ADMINISTRATIVE REPORT

TO: Vancouver City Council
FROM: Director of Current Planning
SUBJECT: 3325 Kingsway
Development Permit Number DE404251
Owner of Development: Lalli Development Ltd.

3325 KINGSWAY DE404251

DATE: OCTOBER 19, 2010
SCALE: 1/8" = 1'-0"
SHEET: A-3

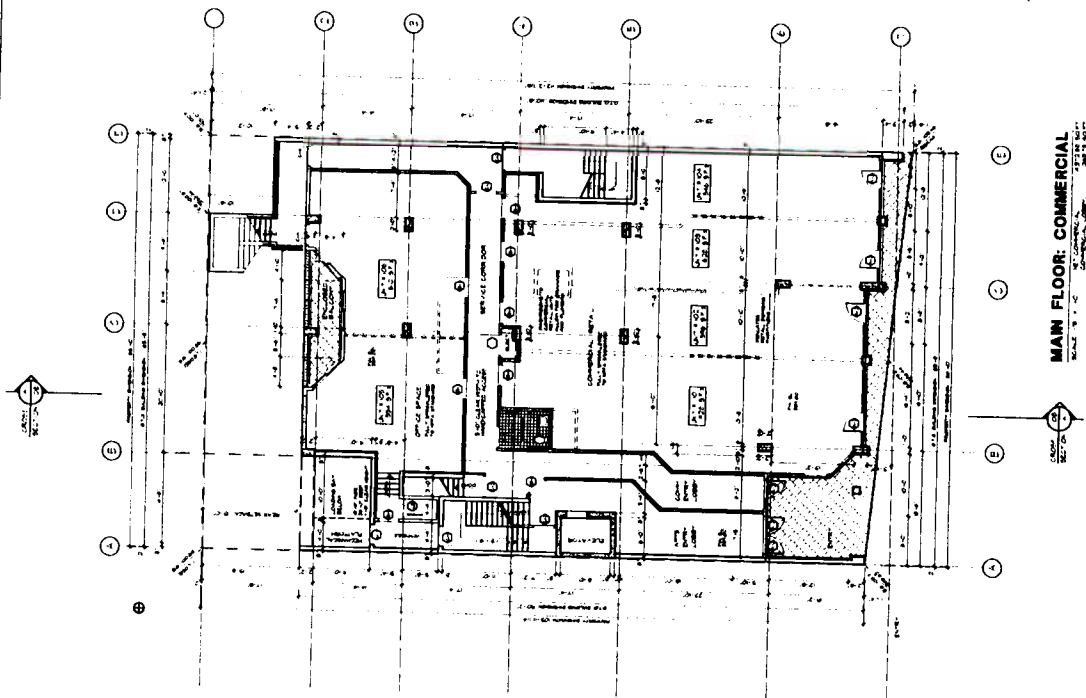
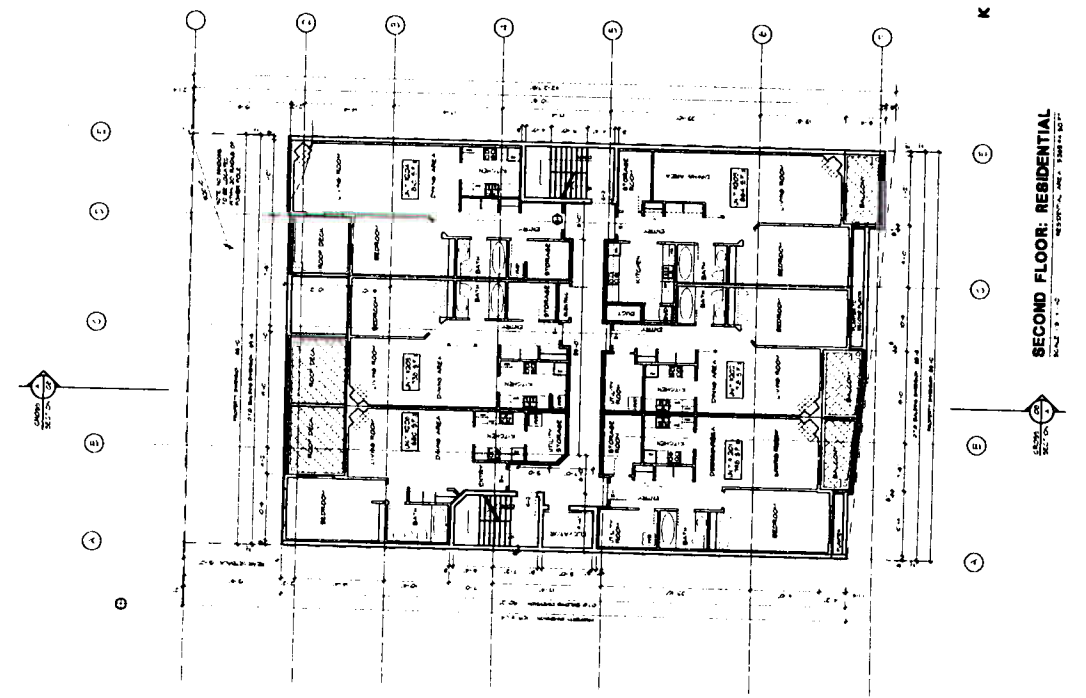
- Residential alcove (relocate entrance to office from east side to west side of building to provide more room and provide access to the elevator);
- The rectangular geometry should find its way to the back of the building as well as the front; and
- The gabled addition could be removed as it is not consistent with the overall design.

Some Panel members expressed concern with the office area access. The office in the rear has a difficult access from Kingsway. A solution suggested was to separate the office entry from the residential entry. A different treatment from the commercial area for the residential entry would also be beneficial. There may be too much of a recessed area at the entrance and it may be better to move the doorway closer to the street. Also, from a safety perspective, the back stairway with masonry walls may result in some safety issues. Sight lines should be checked.

EAST ELEVATION
SCALE 1/8" = 1'-0"

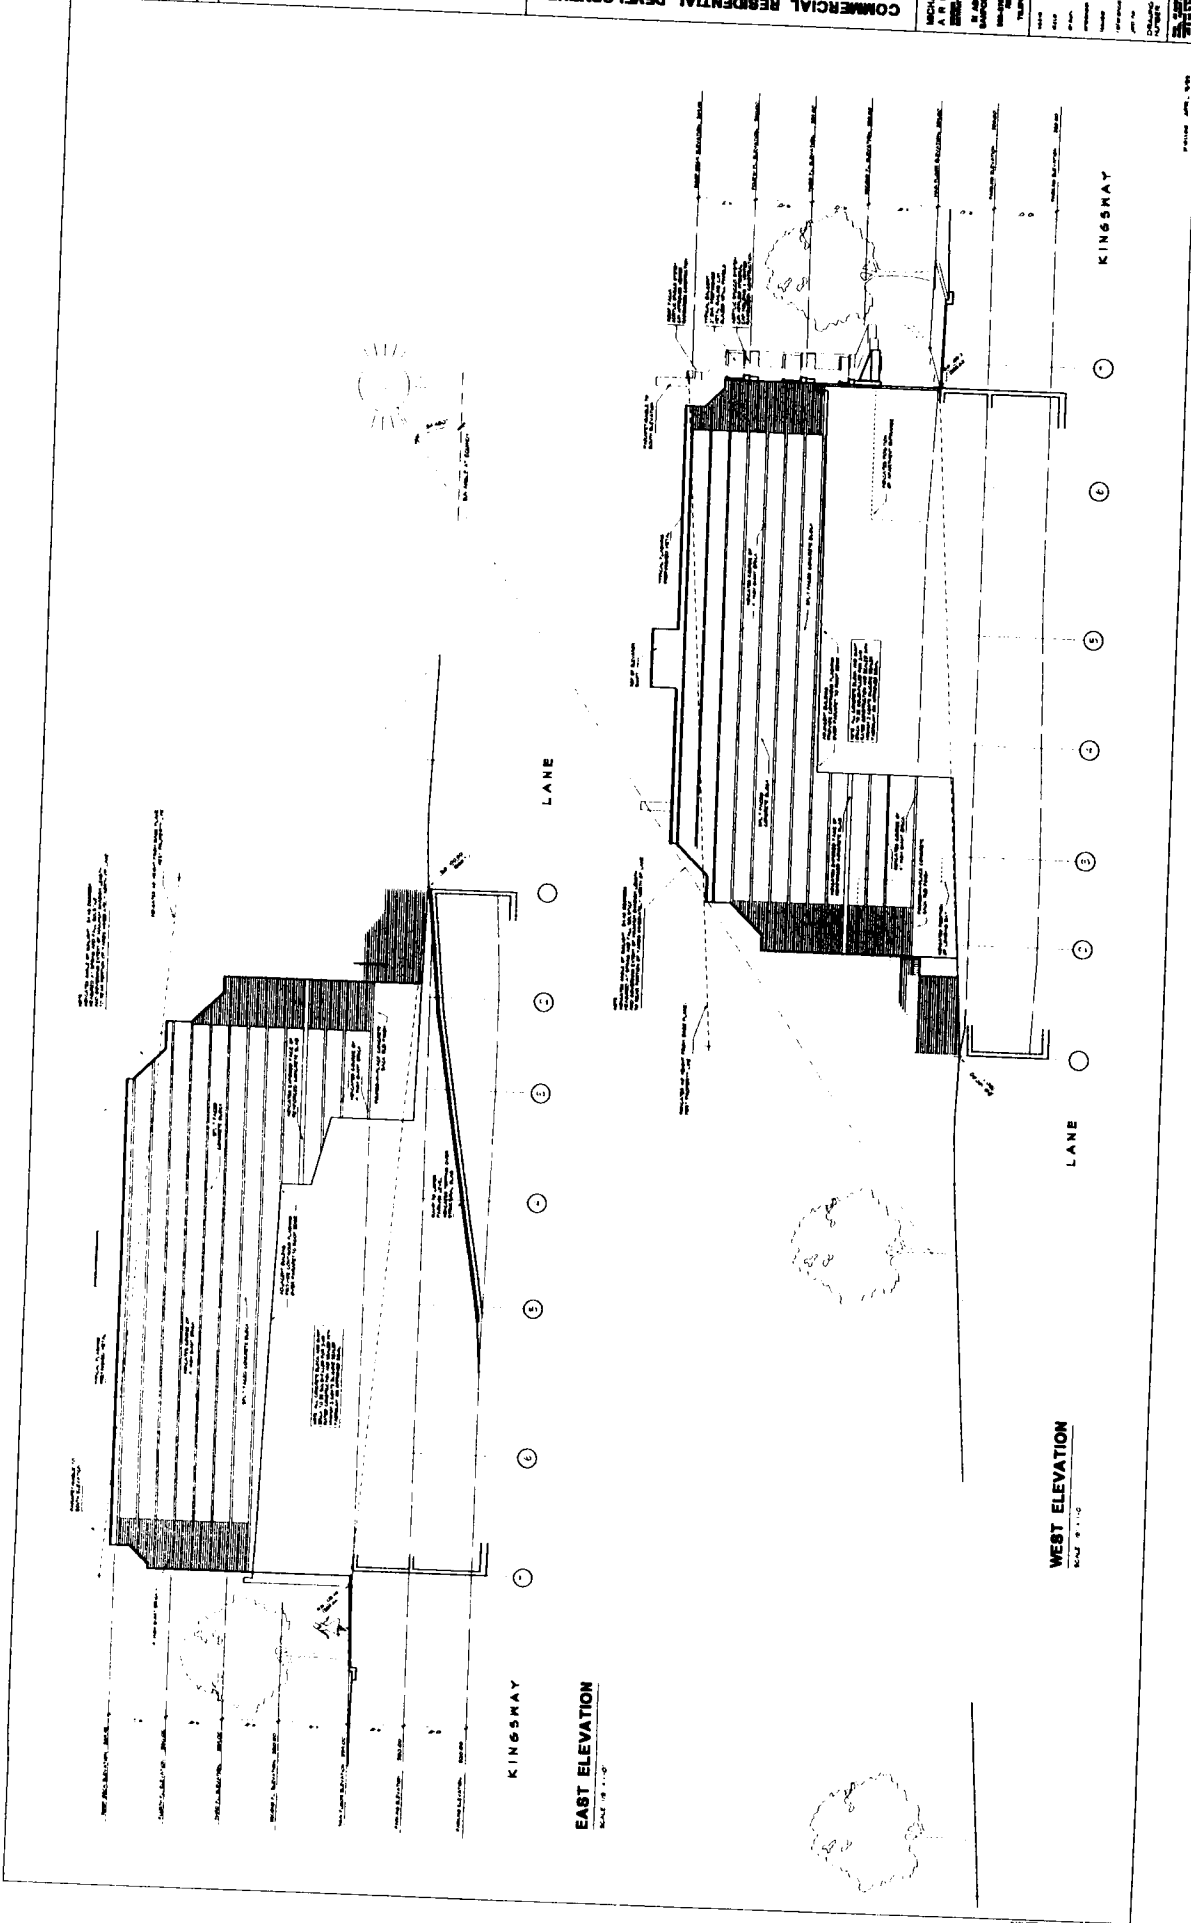
The applicant has minimized the floor-to-floor height of the building in a responsible manner, however, staff have concerns about the impacts of the fourth-storey height, massing and associated FSR facing the RS-1S parcels to the north. In addition, a shadow analysis confirms that the proposed development will increase overshadowing on several adjacent RS-1S backyards contrary to the criteria for sloping sites described under Section 4.3(a) of the Guidelines. Staff, therefore, do not support the requested height relaxation.

The proposed development is too dense for the site when evaluating impacts of massing, density and associated height upon the residential backyards to the north. Staff, therefore, are recommending that the fourth-storey (five-storeys facing the lane) be reduced by approximately one-half via a single loaded corridor to mitigate against the impacts. Staff anticipate this would reduce the FSR by 0.43, thereby bringing the building into compliance with the 2.0 FSR contemplated within the Guidelines.

Staff believe that a reduction in the uppermost storey of the proposed development would achieve compliance with height, massing and density requirements of the Guidelines and meet the intent of Council's revised C-2 policies. Planning staff therefore support revisions to this development application with design conditions. However, before making a decision, the Director of Planning is seeking any advice which Council may wish to provide.
